Access Compliance Report

Public Rights-of-Way

Intersection ID: 3143	Main Street: MALLARD_WOODS_PL	Cross Street: LAWRENCE_GRAY_RD	Location: SW
ADA ID: 4E23B23F6658	Ramp Type: Perp	Initial Pass/Fail: Fail	Overall Compliance: No
			Severity Score: 50

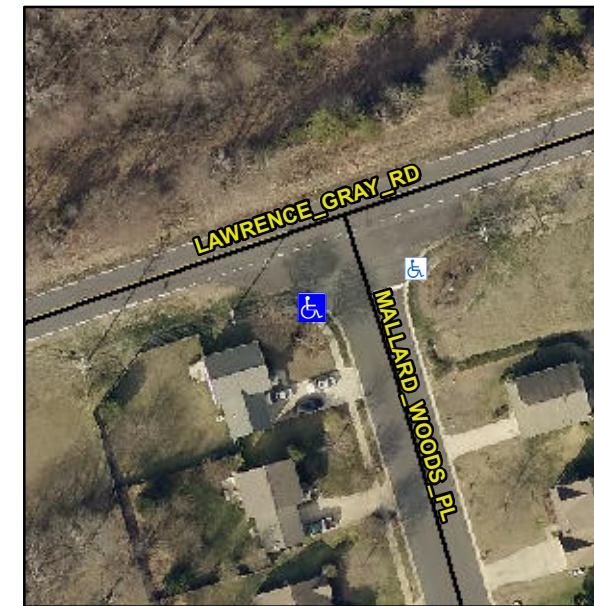
Not Found, R304.2.2, R304.5.3

Compliance	Description	Data	Compliance	Description	Data
N/A	Ramp Length (in)	46.0	No	Ramp Slope (%)	12.0
Yes	Ramp Width (in)	72.0	No	Ramp XSlope (%)	7.7
N/A	Flare Type LT	N/A	N/A	Flare Type RT	N/A
N/A	Flare Slope LT (%)	N/A	N/A	Flare Slope RT (%)	N/A
N/A	Flare Traversable LT?	N/A	N/A	Flare Traversable RT?	N/A
N/A	Landing Length (in)	N/A	N/A	DWS Provided?	N/A
N/A	Landing Width (in)	N/A	N/A	DWS Contrast?	N/A
N/A	Landing Slope (%)	N/A	N/A	DWS Length (in)	N/A
N/A	Landing X Slope (%)	N/A	N/A	DWS Full Width?	N/A
N/A	Landing Curb? (Y/N)	N/A	N/A	DWS Offset (in)	N/A
N/A	Shared Landing?	N/A			
N/A	Gutter Ponding?	N/A	N/A	Gutter Slope (%)	N/A
N/A	Gutter Lip Ht (in)	1.0	N/A	Gutter X Slope (%)	N/A
N/A	Painted X Walk1?	No	N/A	Painted X Walk2?	N/A
	X Walk 1 Direction	To E		X Walk 2 Direction	N/A
N/A	X Walk 1 Width (in)	N/A	N/A	X Walk 2 Width (in)	N/A
	X Walk 1 Slope (%)	6.8		X Walk 2 Slope (%)	N/A
	X Walk 1 X Slope (%)	0.8		X Walk 2 X Slope (%)	N/A

Remove & Replace Entire Ramp.
